## **TURPENTINE HILL SUBDIVISION**

APPLICATION NUMBER 2 DATE June 1, 2006

REQUEST Subdivision

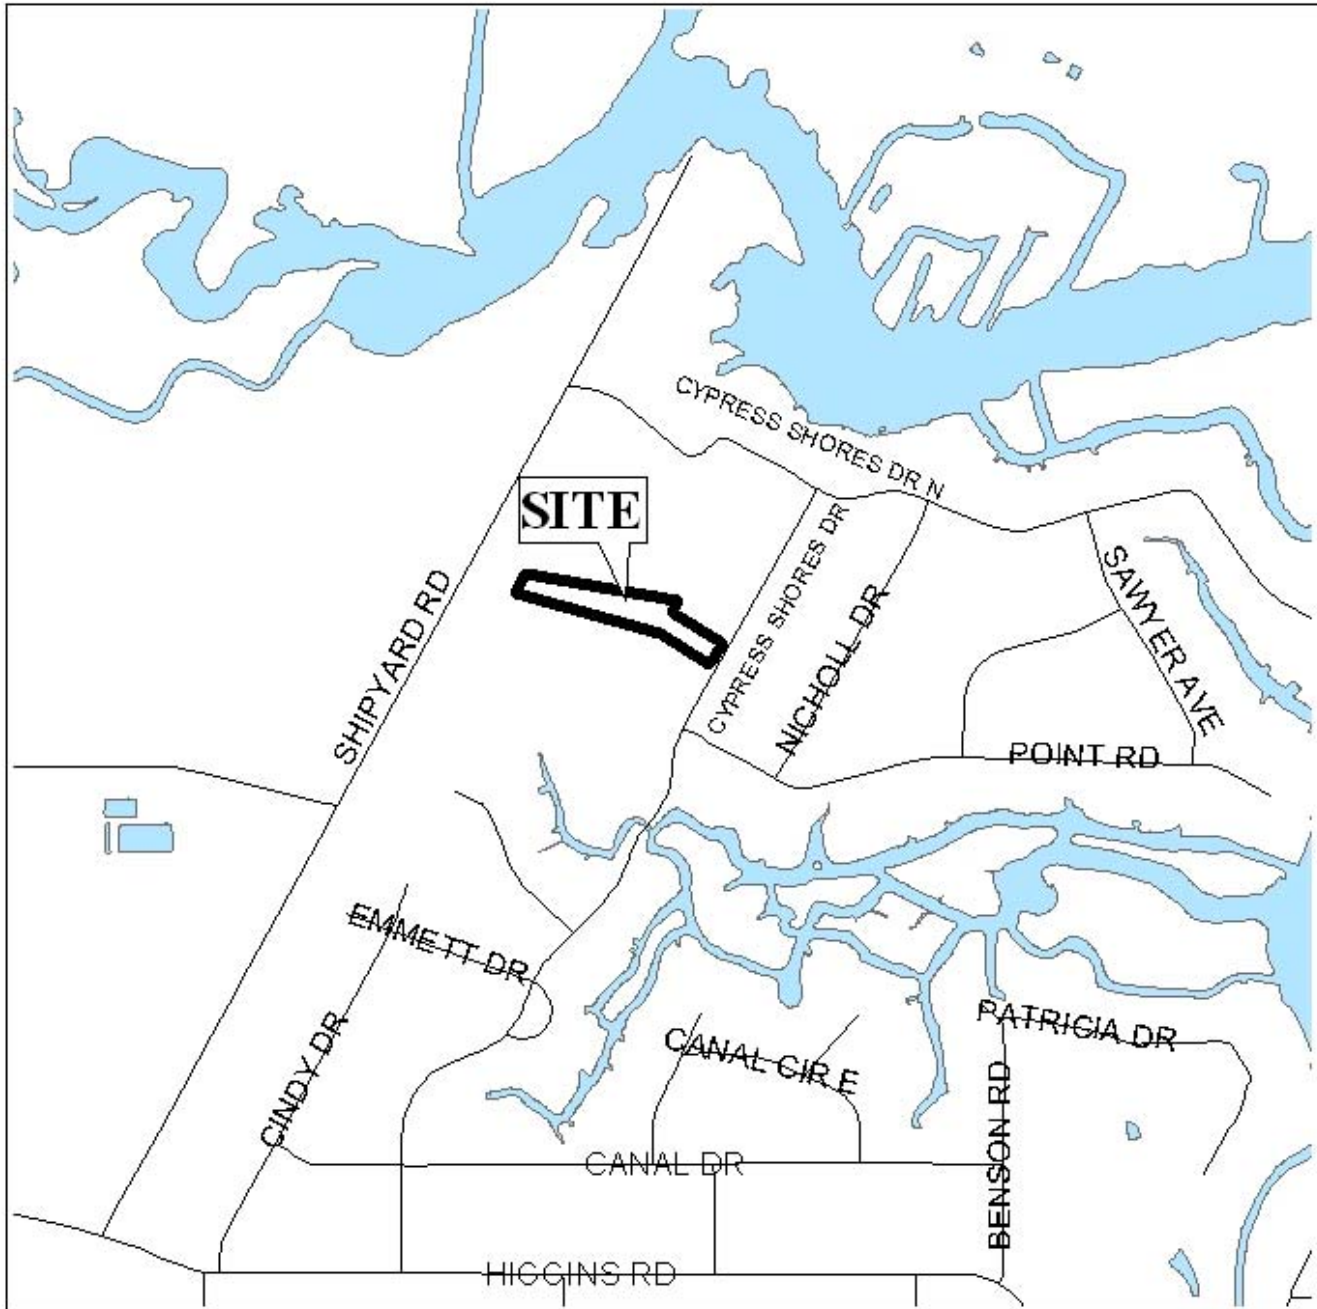
The plat illustrates the proposed 2.5± acre, one-lot subdivision, which is located on the West side of Cypress Shores Drive, 260'± North of the West terminus of Point Road and is in Council District 4. The site is served by public water and sanitary sewer.

The site fronts Cypress Shores Drive, which has a 60-foot right-of-way, and adjoins a railroad right-of-way at the rear. The plat illustrates a 30-foot building setback from Cypress Shores Drive. As a means of access management, the site should be limited to a single curb cut.

The site is partially within the AE floodplain, and may be environmentally sensitive; therefore the approval of all applicable federal, state, and local agencies would be required prior to the issuance of any permits.

The site would exceed the maximum depth ratio, but would remedy an existing flag-lot situation.

With a waiver of the maximum depth ratio (Section V.D.3), the plat would meet the minimum standards of the Subdivision Regulations, and is recommended for Tentative Approval, subject to the following conditions: 1) the approval of all applicable federal, state, and local agencies prior to the issuance of any permits; 2) depiction of the 30-foot building setbacks as shown on the preliminary plat; and 3) the placement of a note on the final plat stating that the site is limited to a single curb cut.
